Subject: B19003074, Future Basement Plan

**From:** Freemon, Robert  
**Sent:** Friday, October 18, 2019 12:09 PM  
**To:** Jasmine Strain  
**Cc:** Steve Appler; Anest, Cathy; Williams, Jeffrey; Mock, Don; Wolf, Kevin  
**Subject:** RE: 5104 Mountain Lane  
**Attachments:** Bedroom Memo.pdf; Health Floor Plans.pdf

# CAIRN CUSTOM HOMES OJO RESIDENCE

CONTENT  
**FOUNDATION PLAN**

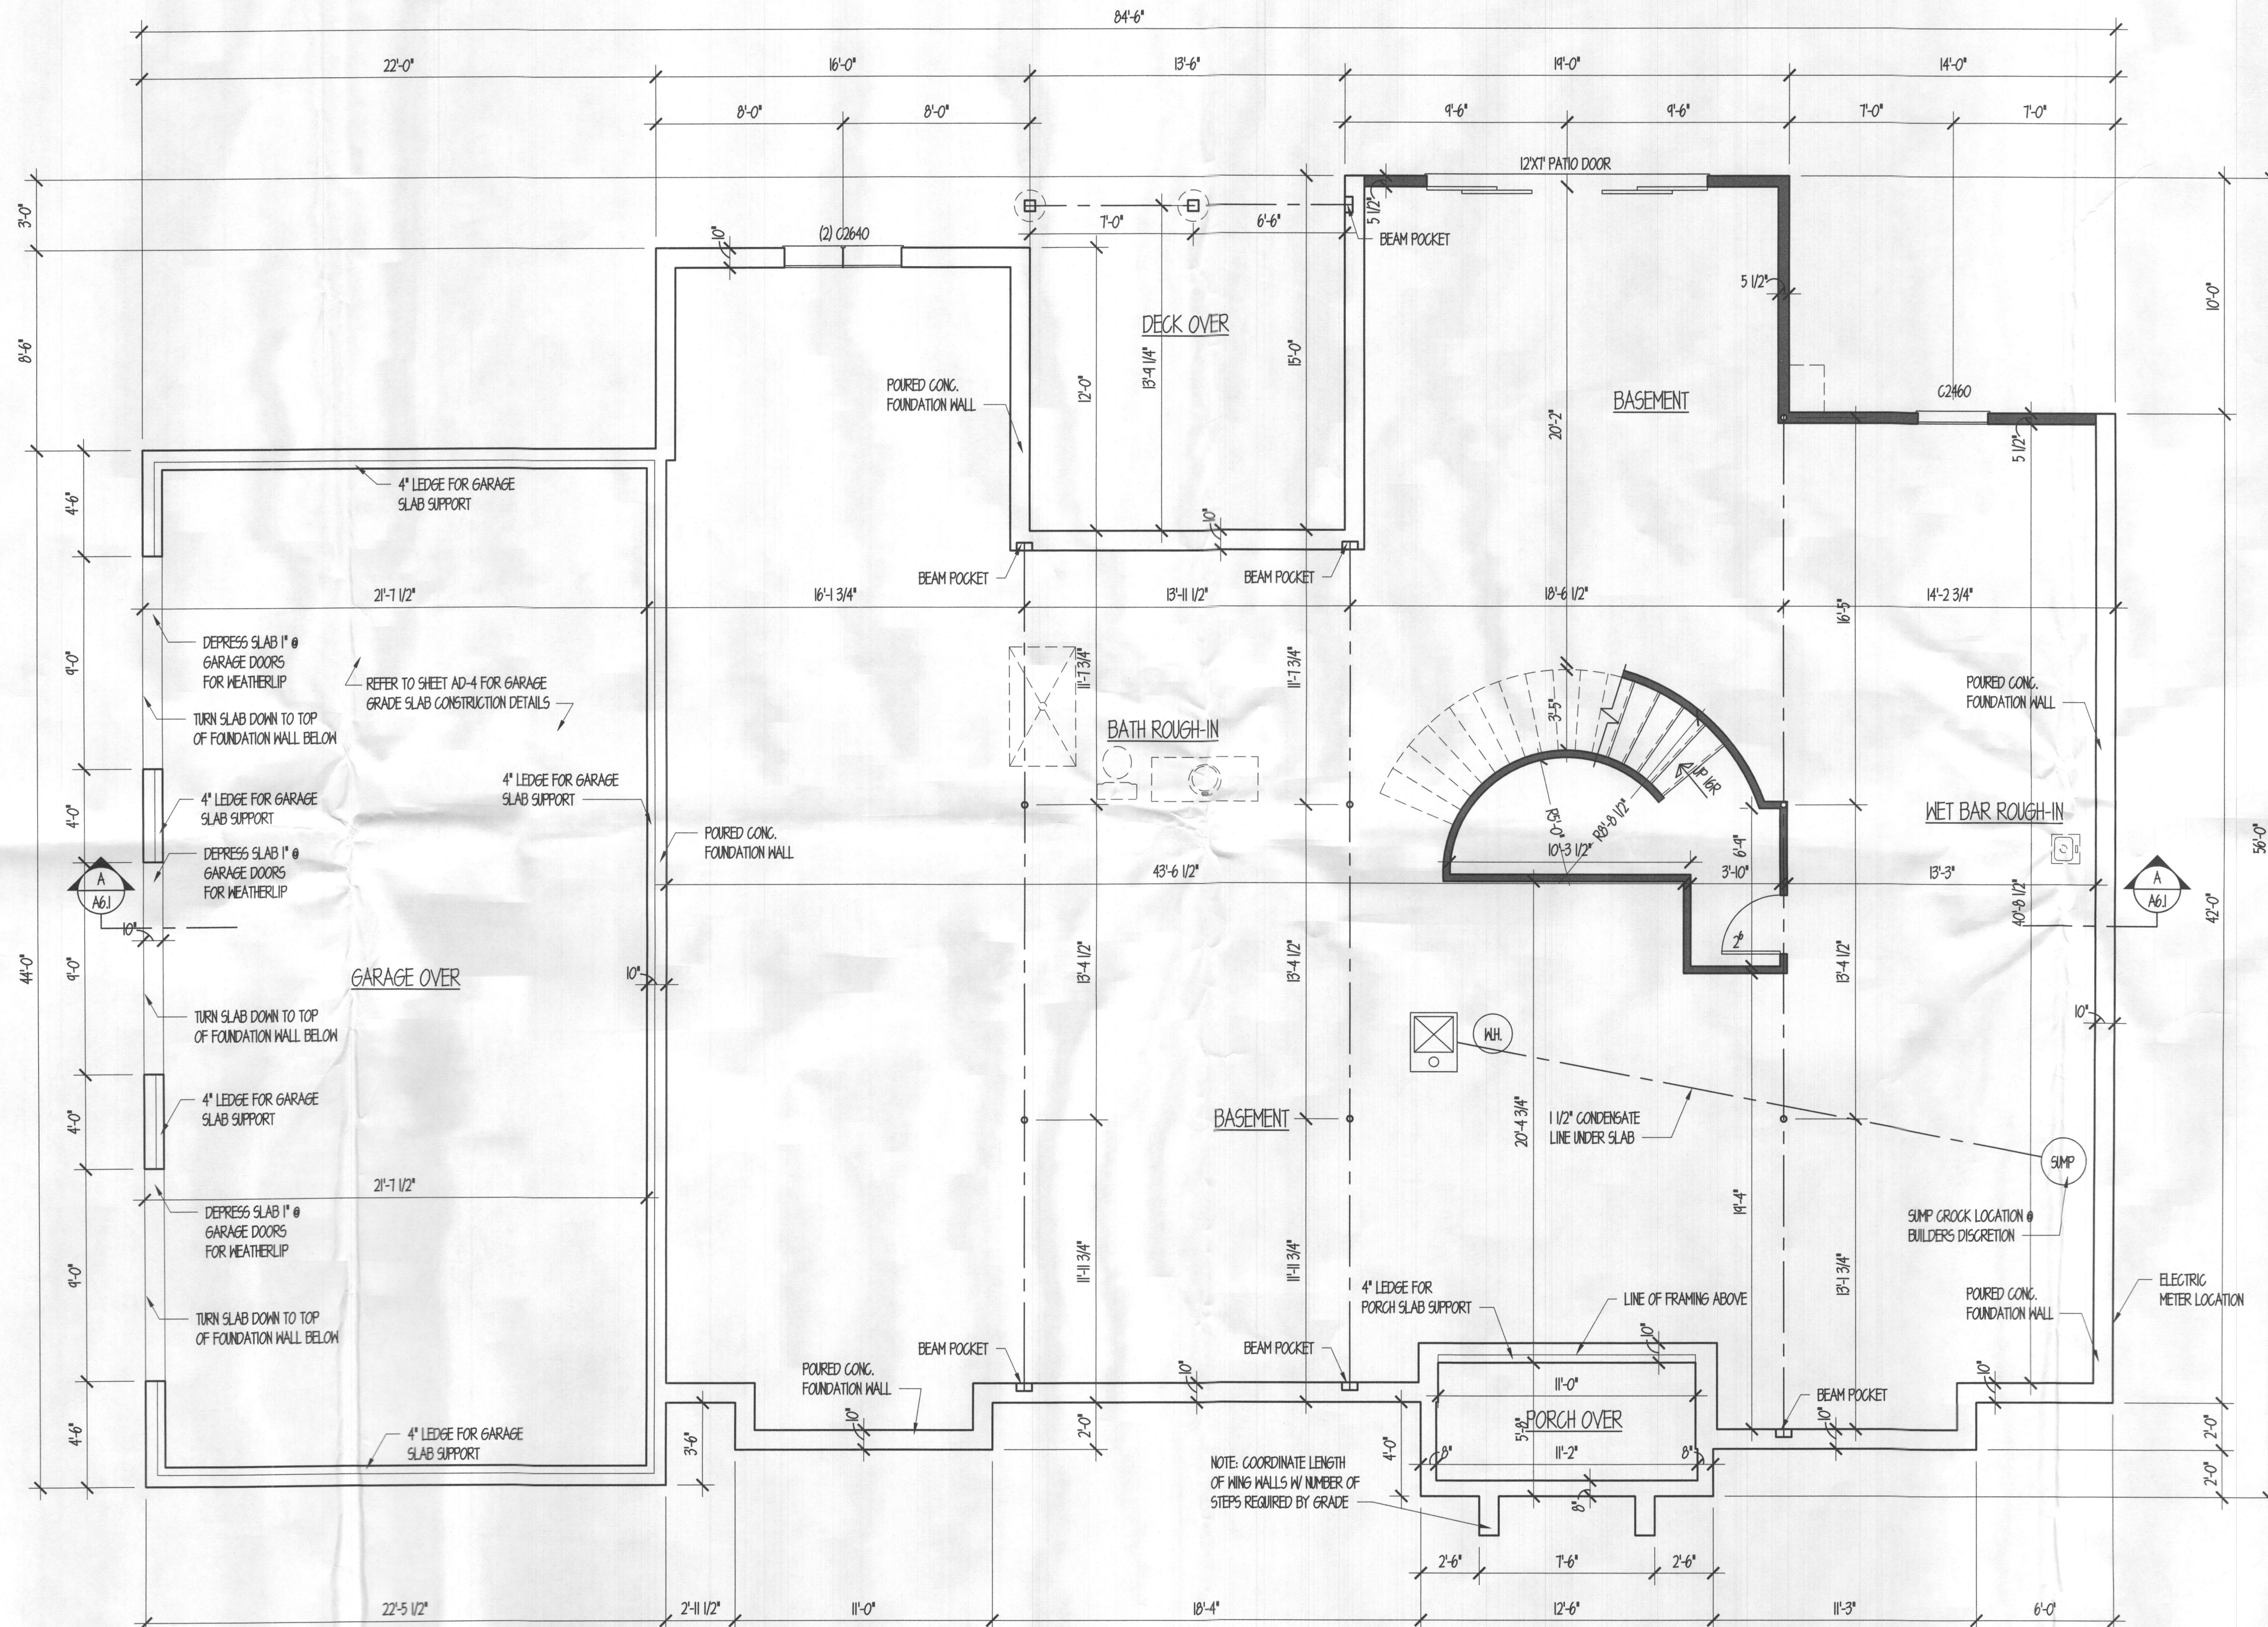
It has been brought to my attention both the BP summaries and the floor plans received by DILP and Health differ in the construction of the basement. Accella's BP summary states, "Full Basement, Basement = Partially Finished" while the paper copy of the BP received by Health states, "Unfinished Basement". The floor plans reviewed by DILP show a finished "Future Den" on a "Finished Basement Plan" while the floor plans submitted to Health make no mention of this. The floor plans Health received show an entirely unfinished basement. This "Future Den" meets Health's definition of a bedroom therefore making it a 6<sup>th</sup> bedroom in a dwelling restricted to 5 bedrooms due to the shared septic system serving it. Can you clarify this discrepancy?

The issue is now resolved and the hold has been taken off of this permit at DILP.
